## **ADDENDUM NO. 2**

### **2013 - Adirondack Loj Road Bridge Replacement**

**Essex County, NY**

**June 19, 2013**

CLIENT NAME  
**ESSEX COUNTY DEPARTMENT OF PUBLIC WORKS**  
Elizabethtown, N.Y.

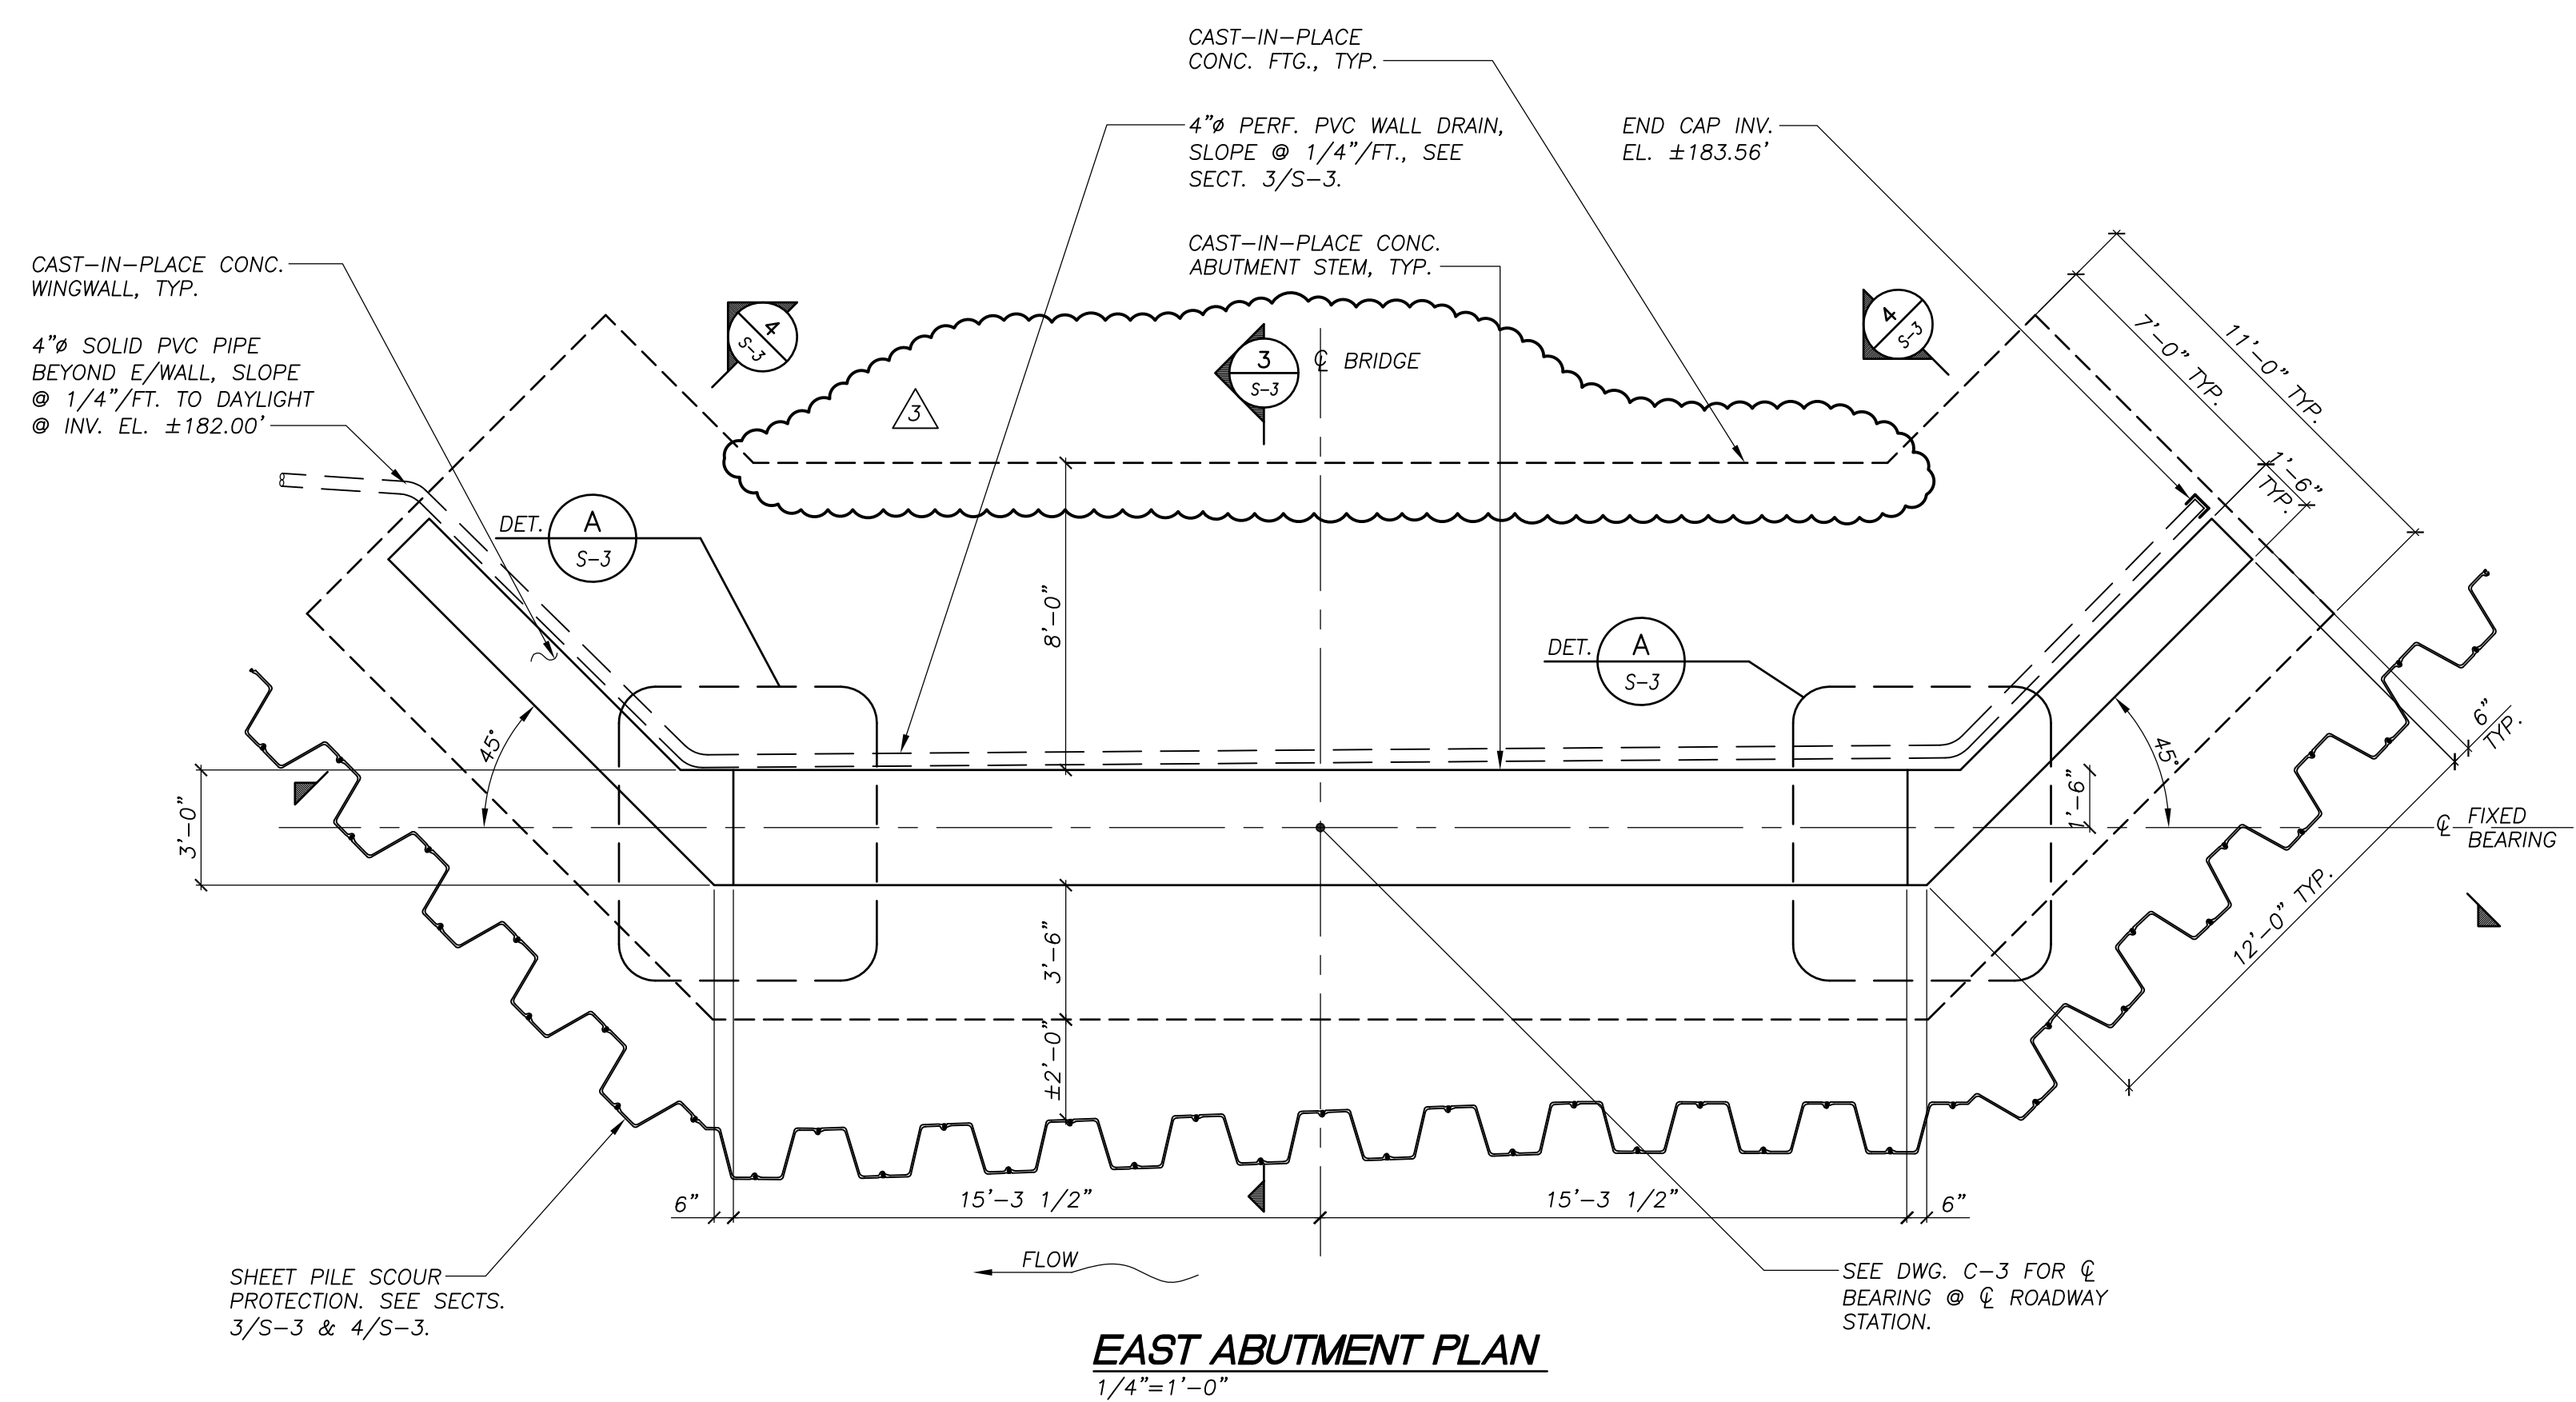
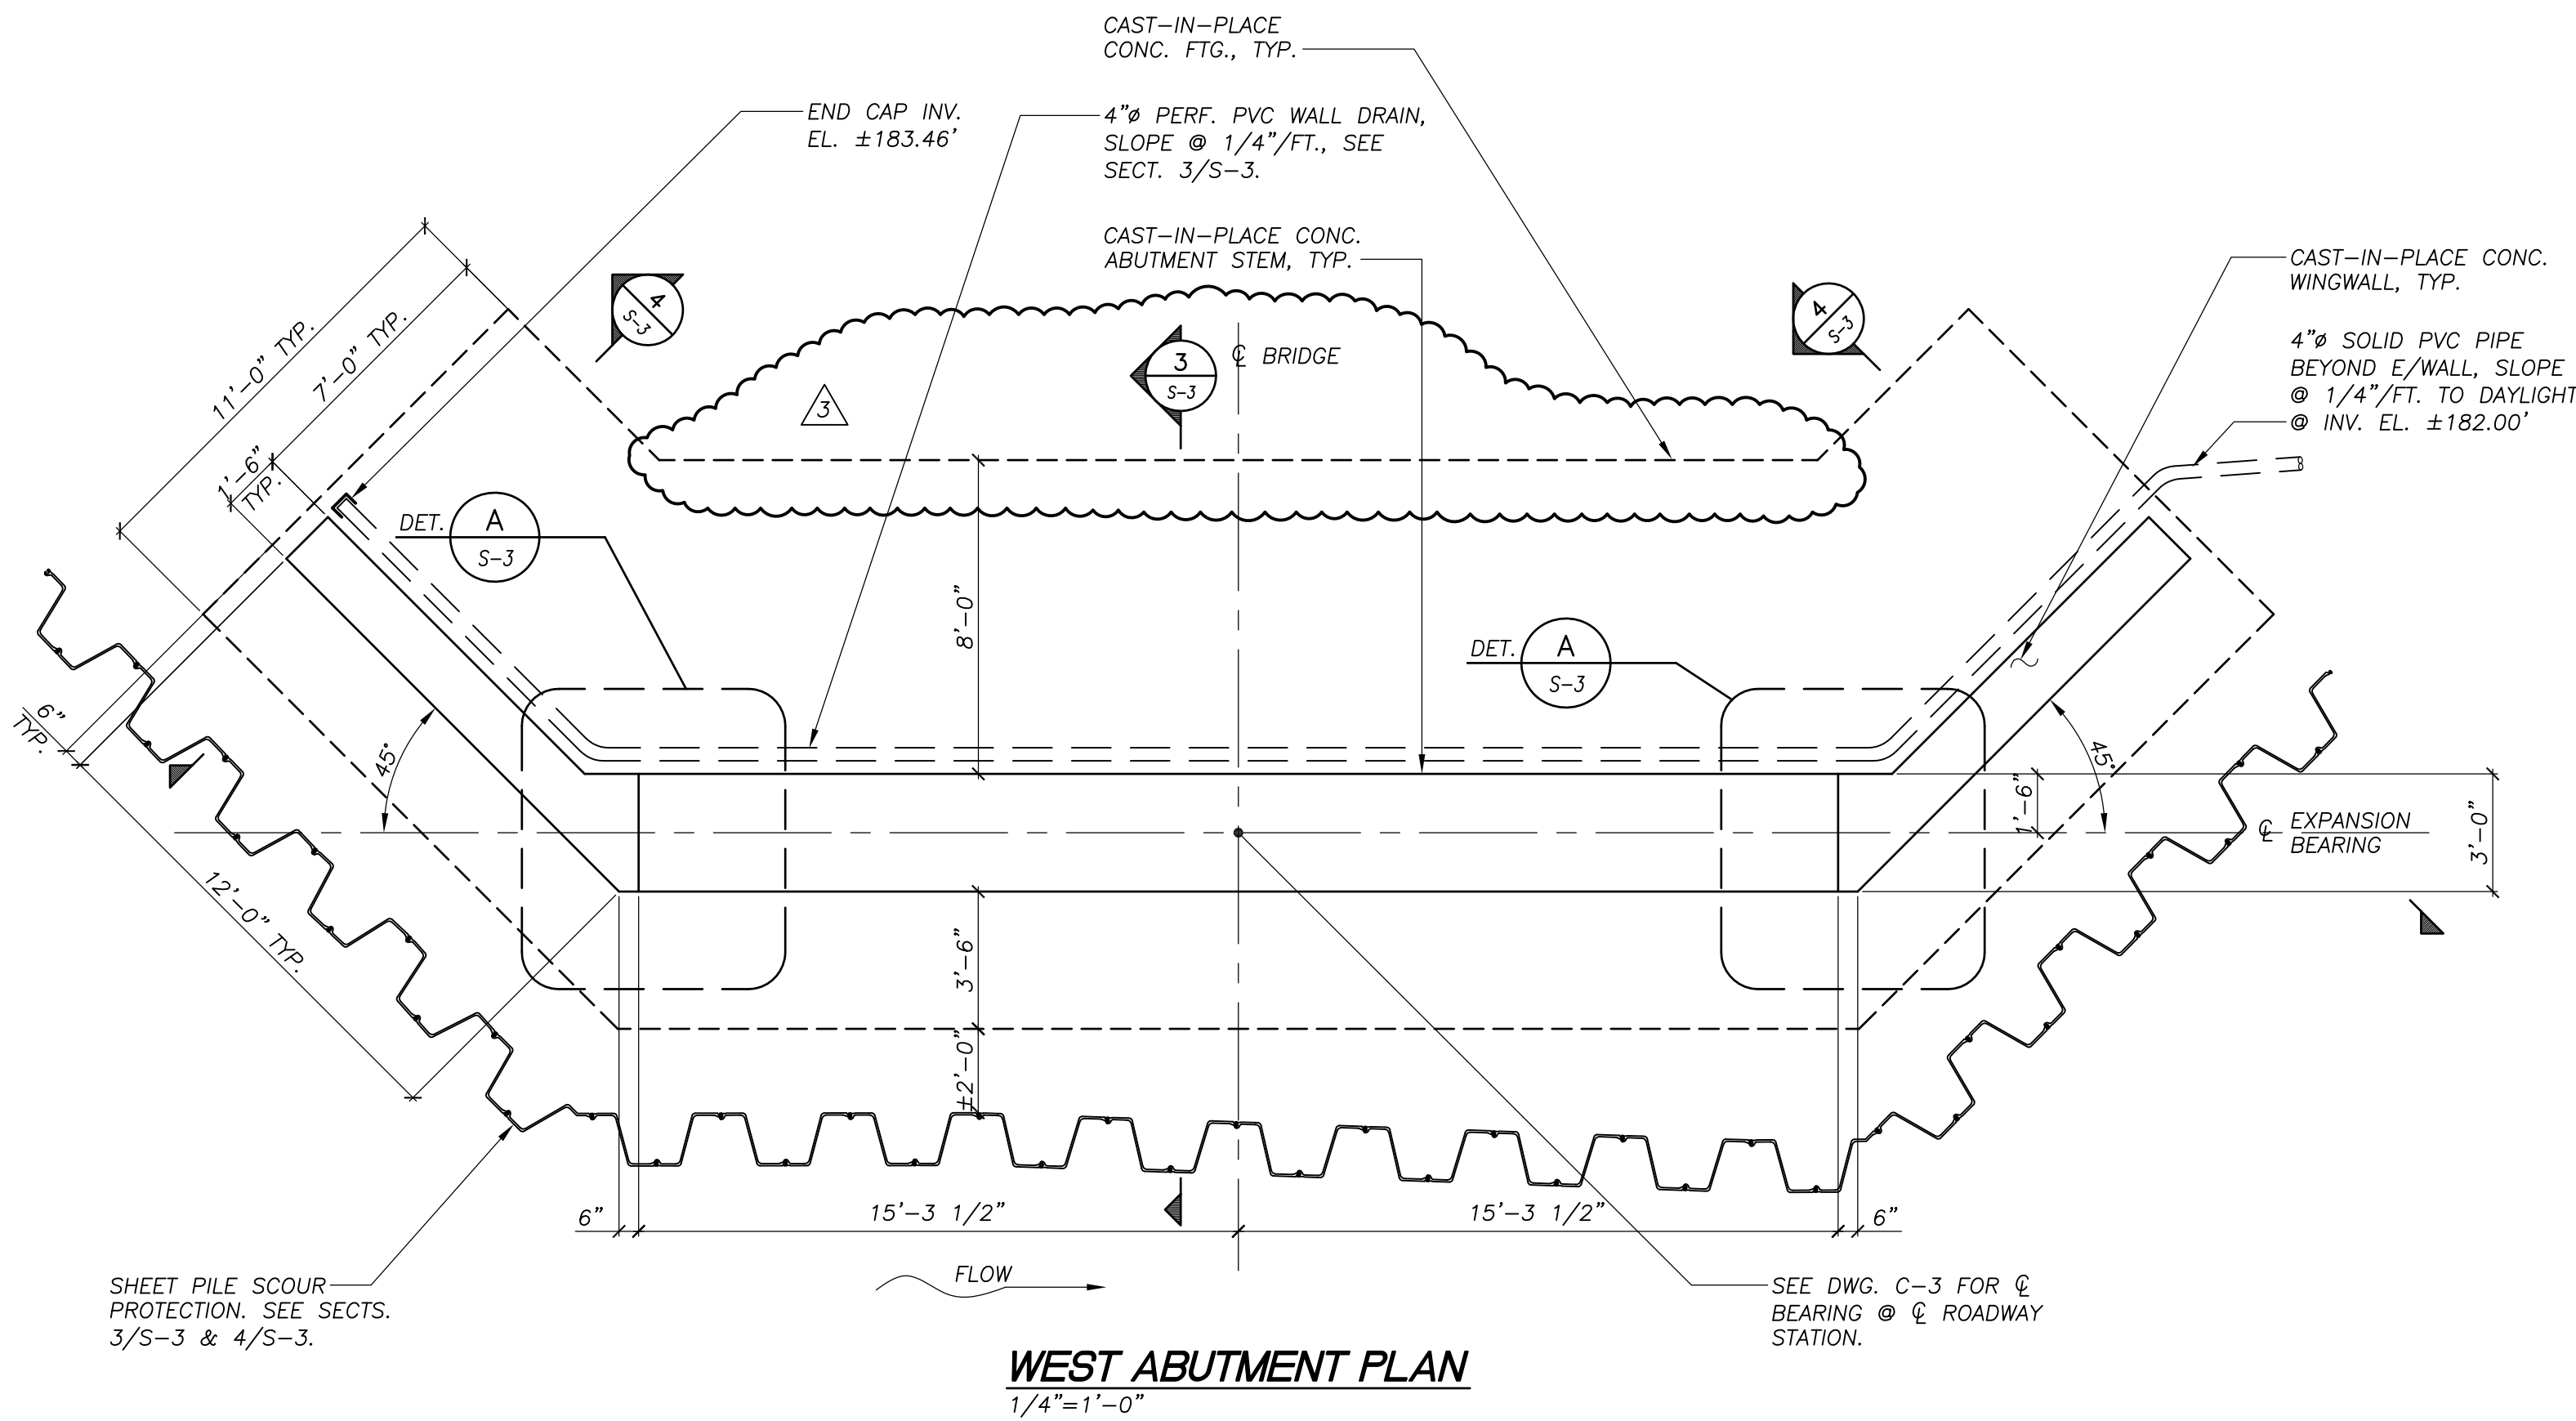
3. Schoder noted that the sheet pile scour protection at the abutments indicated on Drawings S-2 and S-3 must be driven to the depths indicated. The bidders shall include in their bids all costs for the installation of such sheetpiling including the use of driving shoes, pre-driven H-piles to loosen existing soils for sheetpile installation, and any other means or methods determined to be necessary by the contractor for the installation of the indicated sheetpiling.
